## REVISED RESPONSE TO REQUEST FOR ADDITIONAL INFORMATION

### APR1400 Design Certification

Docket No. 52-046

RAI No.: 481-8546  
SRP Section: 16 – Technical Specifications  
Application Section: 16.3.4, 16.3.5, 16.3.6, 16.3.7, 16.3.9  
Date of RAI Issue: 05/12/2016

Figure 4.3-1 (page 1 of 1)  
Discrete Two Region Spent Fuel Storage Rack Layout

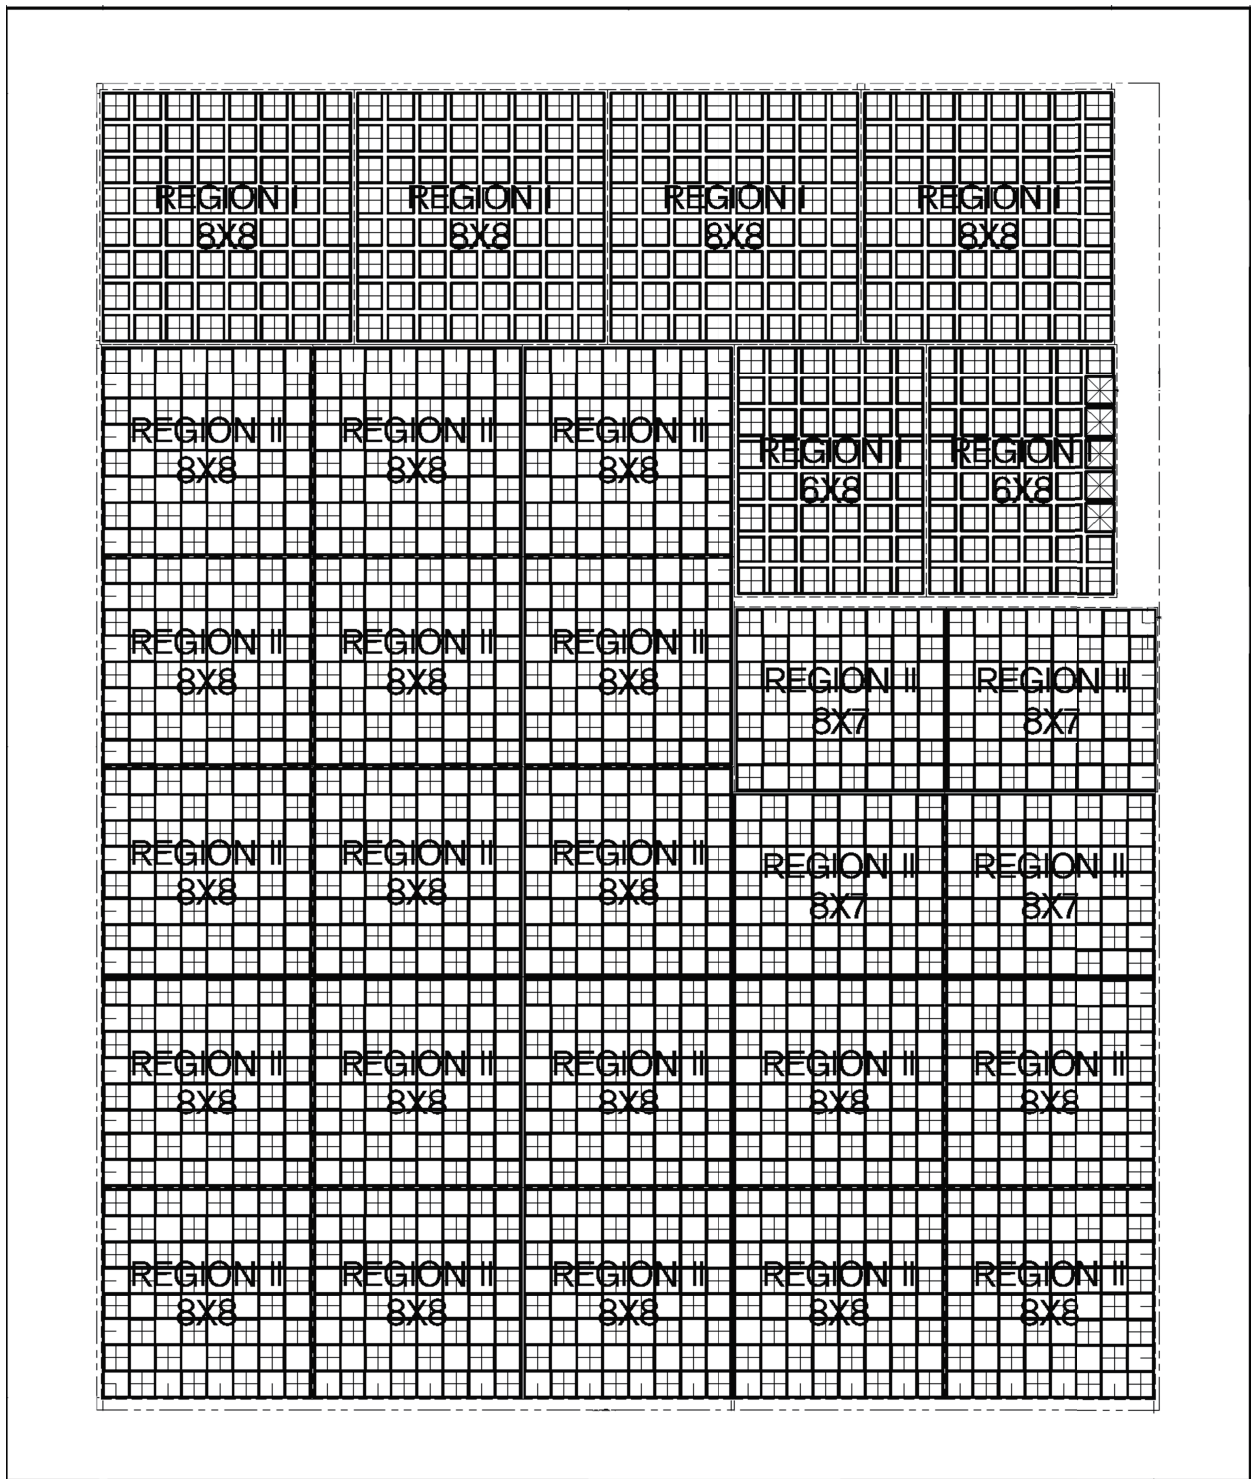
- A. Revise the proposed change to TS 4.3.1.1.b to reflect the design criteria for spent fuel storage racks described in DCD Subsection 9.1.1.
- B. Add a Figure to Section 4.3 showing the physical lay-out of the spent fuel pool that clearly identifies the locations of Region I and Region II storage racks within the spent fuel pool.
- C. Revise the Background section of the Bases for TS 3.7.16 to include a discussion of the minimum boron concentration credited in the criticality analysis that is described in DCD Subsection 9.1.1.
- D. Add TeR APR1400-Z-A-NR-14001-P, Rev.0 to the References section of the Bases for TS 3.7.16.

2. Editorial clarification in the response to RAI 120-7977, Subquestion 3 will be revised.
3. TS Bases B 3.7.5 LCO section will be revised to include suggested changes for clarify.
- 4-A.TS 4.3.1.1.b, e and f will be revised as indicated in the attached markup.
- 4-B.Figure 4.3-1 will be added to identify the locations of Region I and Region II storage racks within the spent fuel pool.
- 4-C.Background section of the Bases for TS 3.7.16 will be revised to include a discussion of the minimum soluble boron concentration credited in the criticality analysis.

shall be stored only in the Region I of Figure 4.3-1.

↑  
This figure will be added to Section 4.3
